**COLD PLANING TRANSITIONS**

<b>PROJECT TYPICAL SHEET # 2</b>	PROJECT: <b>VERNON - BRATTLEBORO</b>	PROJECT NO. : <b>AC STP 2126(1)S</b>
	FILE NAME: /pave/98cl84/pcl84.dgn	PLOT DATE: 08-SEP-2009
	IPARM FILE NAME: pcl84pt2.1	SURVEY DATE:
	SURVEYED BY: WILDER/LOCKE	DRAWN BY: WILDER
	SQUAD LEADER:	SHEET: 4 OF 33

**TRANSITION DETAIL**

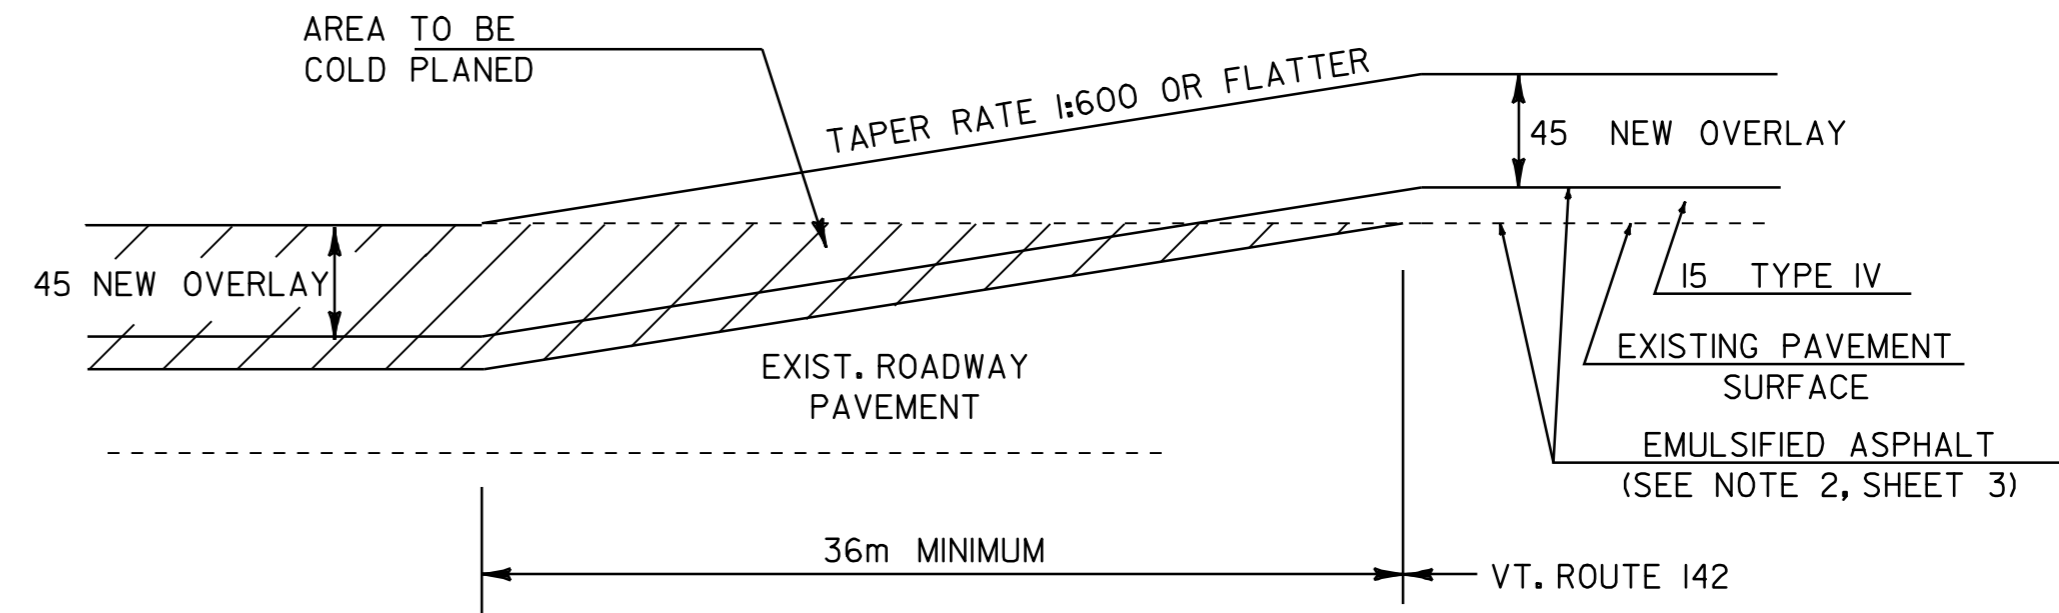
VT. ROUTE 142 (VERNON) STA. 1+734 TO STA. 1+770  
 VT. ROUTE 142 (VERNON) STA. 4+516 TO STA. 4+552 - 4+530~4+566  
 VT. ROUTE 142 (VERNON) STA. 12+264 TO STA. 12+300 - 12+214~12+250  
 VT. ROUTE 142 (BRATTLEBORO) STA. 1+364 TO STA. 1+400 - 1+398~1+434  
~~VT. ROUTE 142 (BRATTLEBORO) STA. 1+400 TO STA. 1+766.62~~

**TRANSITION DETAIL**

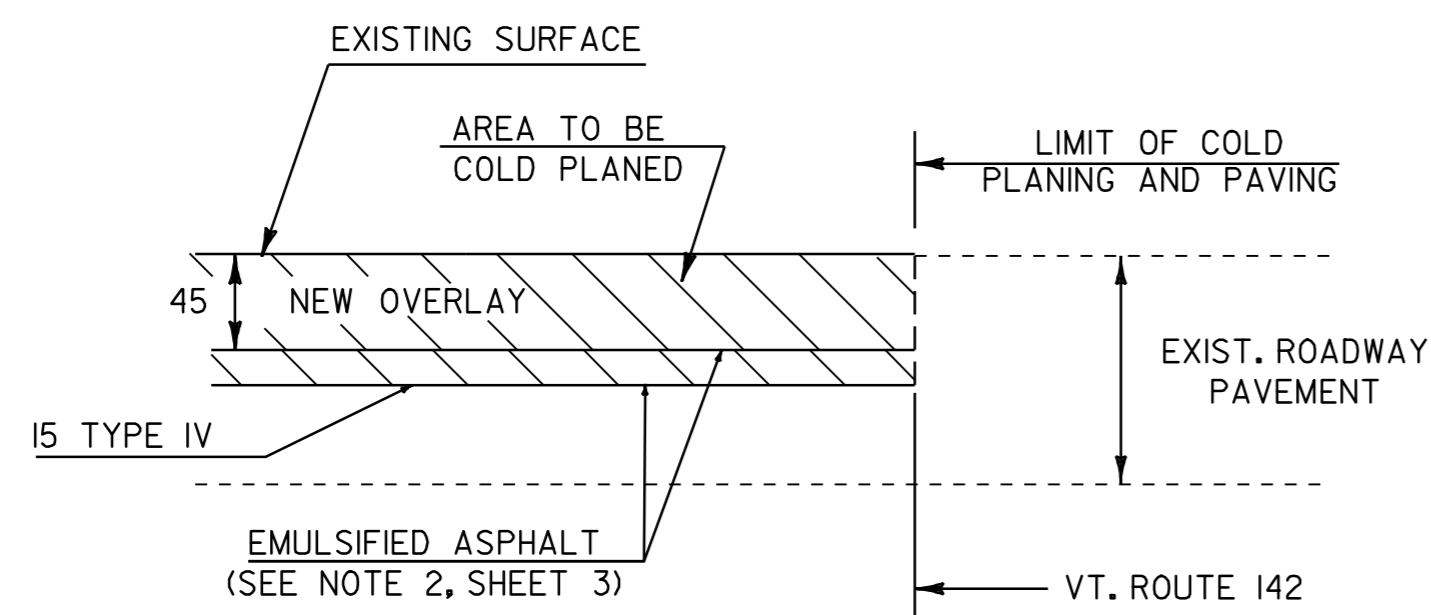
~~VT. ROUTE 142 (VERNON) STA. 1+319 TO STA. 1+355 - 1+300~1+336~~  
~~VT. ROUTE 142 (VERNON) STA. 2+230 TO STA. 2+266 - 2+030~2+066~~  
 VT. ROUTE 142 (VERNON) STA. 5+700 TO STA. 5+736  
 VT. ROUTE 142 (BRATTLEBORO) STA. 0+439 TO STA. 0+475 - 0+412~0+448

**APPROACH AREA DETAIL**

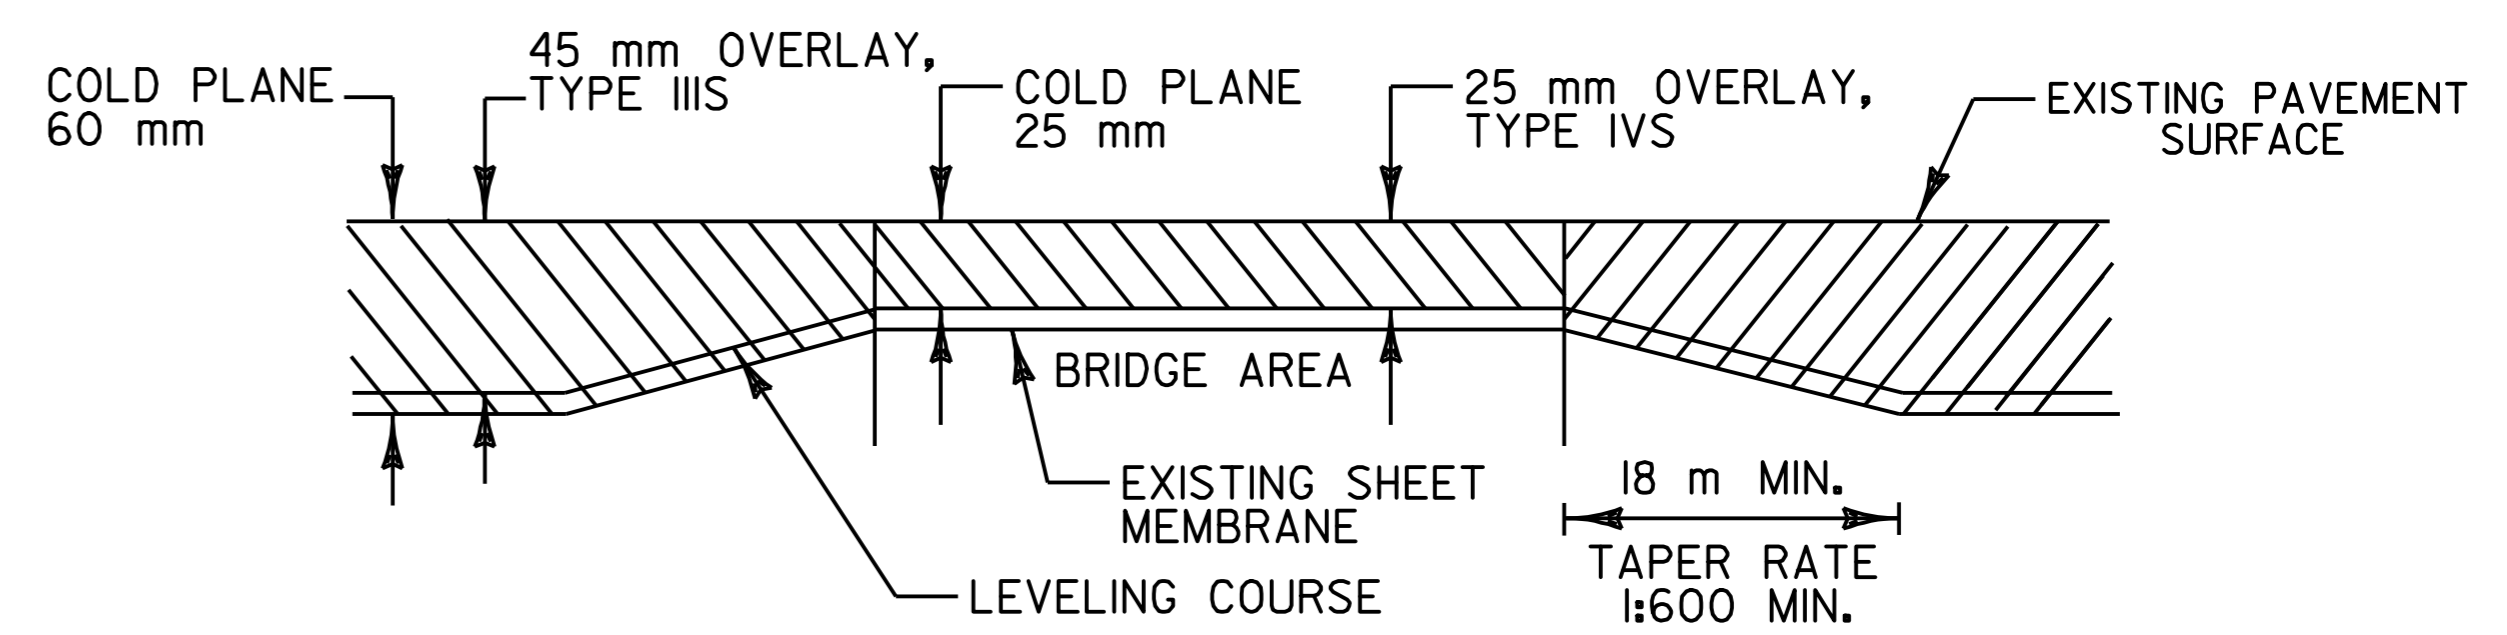
VT. ROUTE 142 (VERNON) STA. 0+000 - STA. 1+319 - 0+015.5~1+300 WORK STARTS IN MASSACHUSETTS.  
 VT. ROUTE 142 (VERNON) STA. 1+770 - STA. 2+230 - 2+030  
 VT. ROUTE 142 (VERNON) STA. 4+552 - STA. 5+700 - 4+566~5+700  
 VT. ROUTE 142 (VERNON) STA. 12+300 - STA. 14+005 - 12+250~13+983  
 VT. ROUTE 142 (BRATTLEBORO) STA. 0+000 - STA. 0+439 - 0+412  
 VT. ROUTE 142 (BRATTLEBORO) STA. 1+400 - STA. 1+766.62 - 1+434~1+778
